Submission for Job: #6011 SSD 6011 - Mixed use residential development within the South West Plot

# SSD 6011 - Mixed use residential development within the South West Plot

**LEVEL 6**

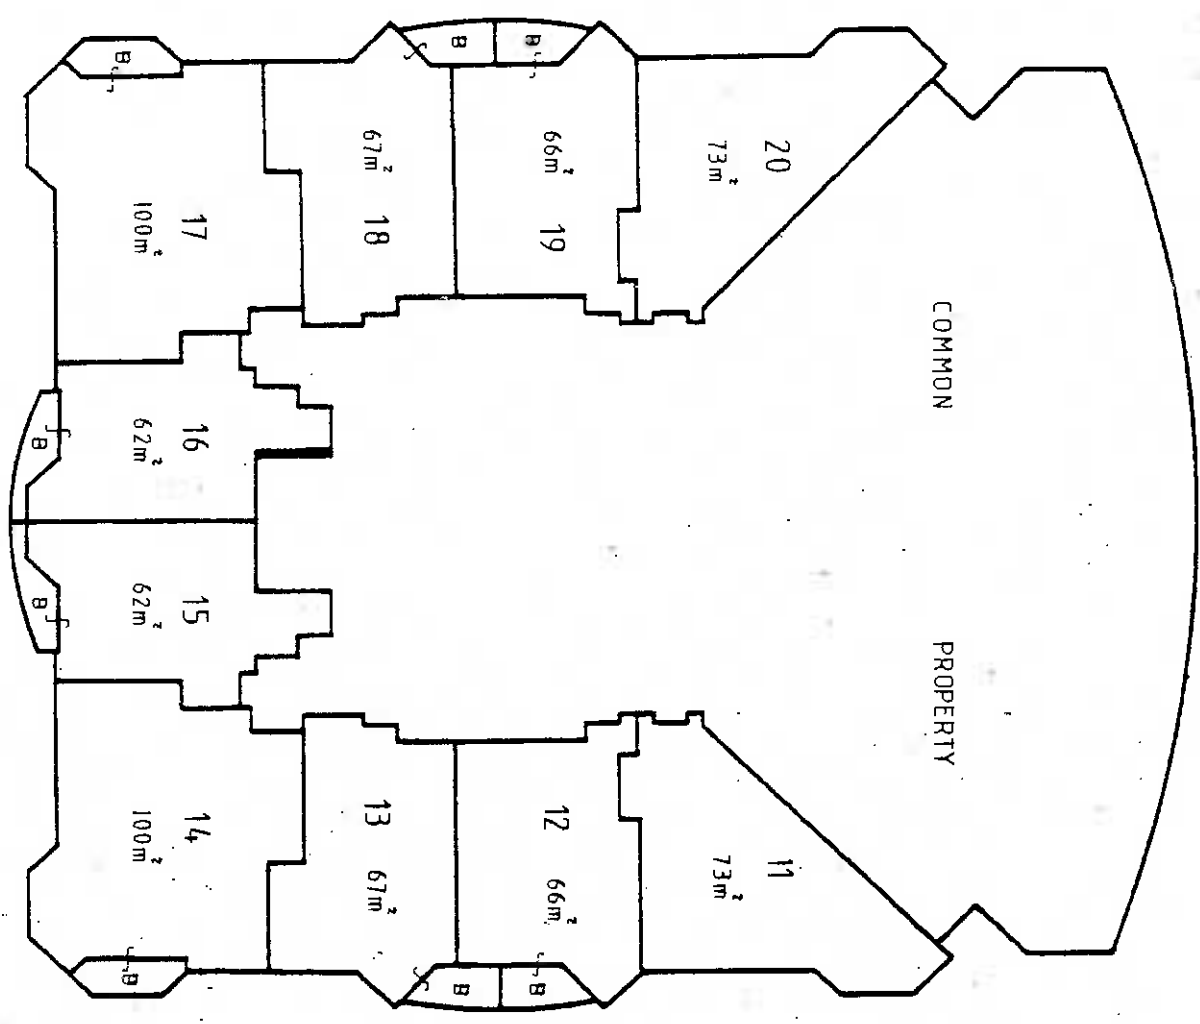
Levels 6 and 7 each contain two apartments with single west aspect , i.e. 4 single aspect apartments.

LEVEL 8

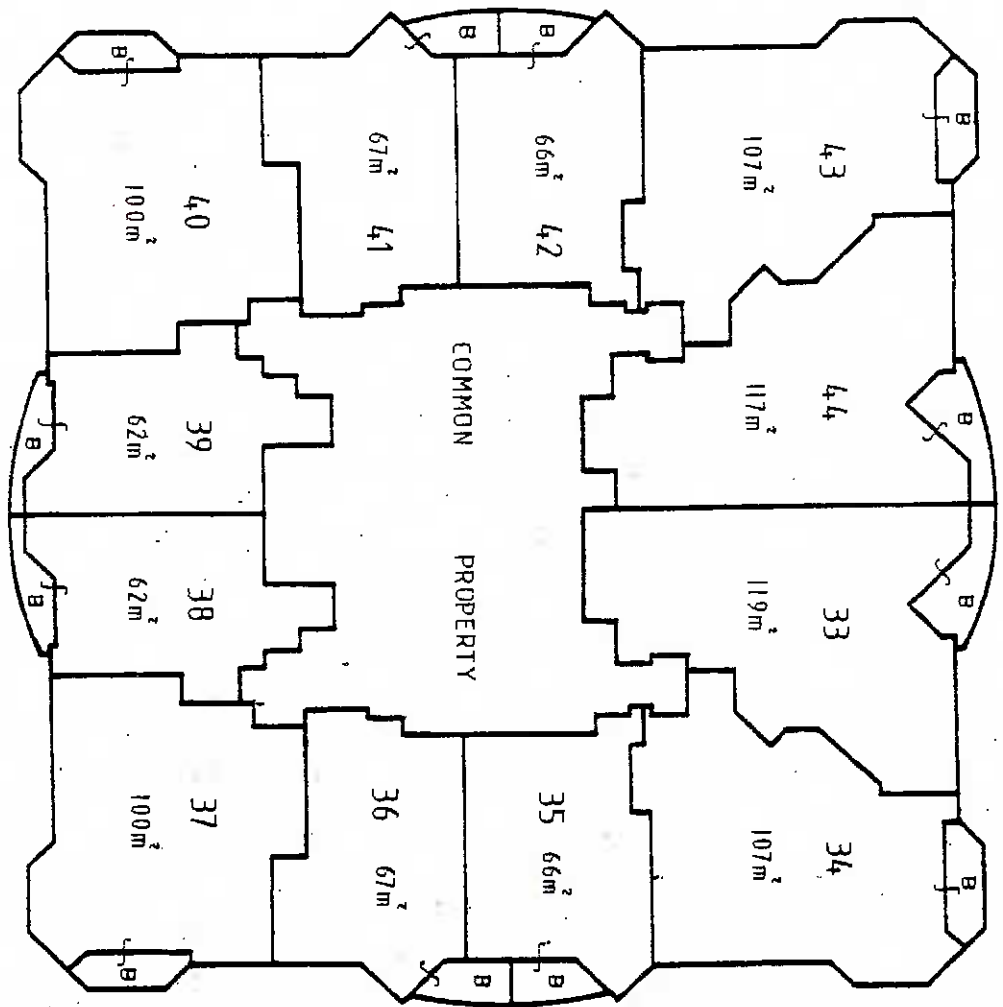
Levels 8-15 each contain two apartments with single west aspect and two apartments with single north aspect , i.e. 4 single aspect apartments per level, giving 32 single aspect apartments.

LEVEL 16

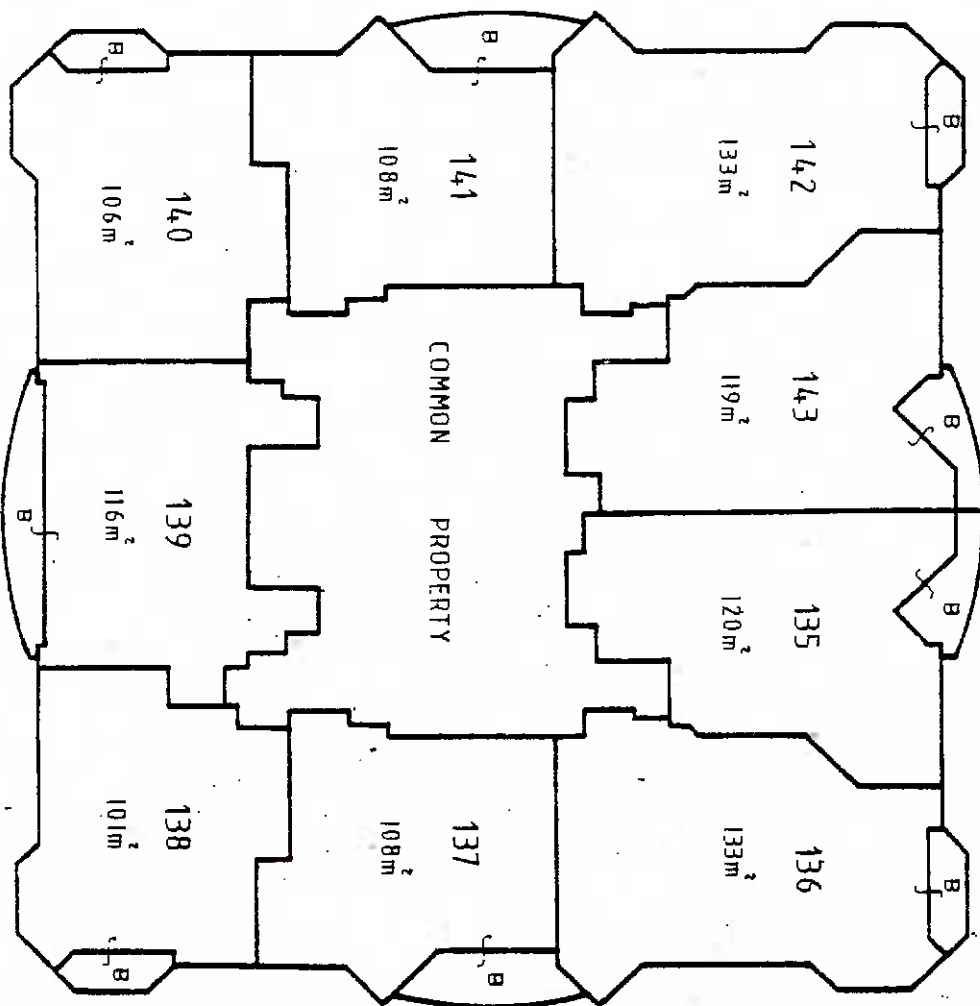
Levels 16-38 each contain one apartment with single west aspect and two apartments with single north aspect, i.e. i.e. 3 single aspect apartments per level , giving 69 single aspect apartments.

LEVEL 39

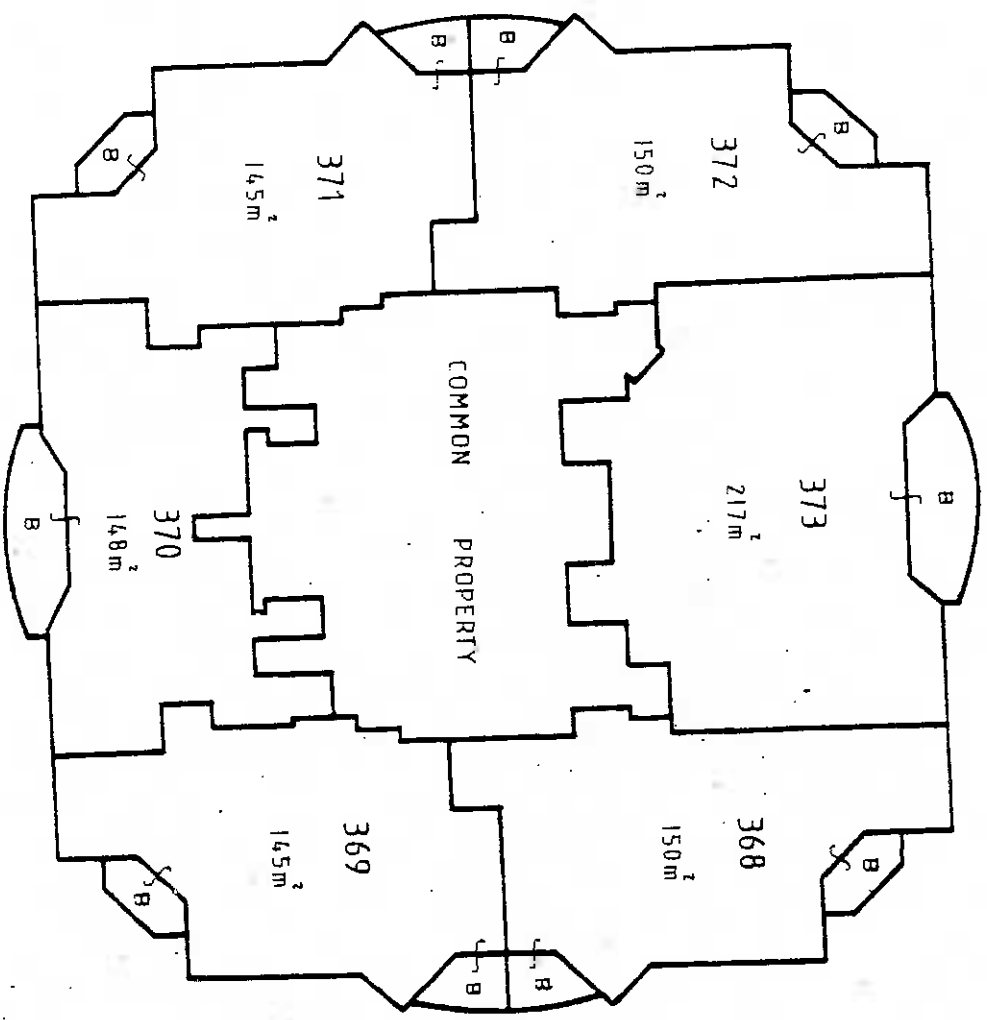
Levels 39-43 each contain one apartment with single north aspect, i.e. 5 single aspect apartments.
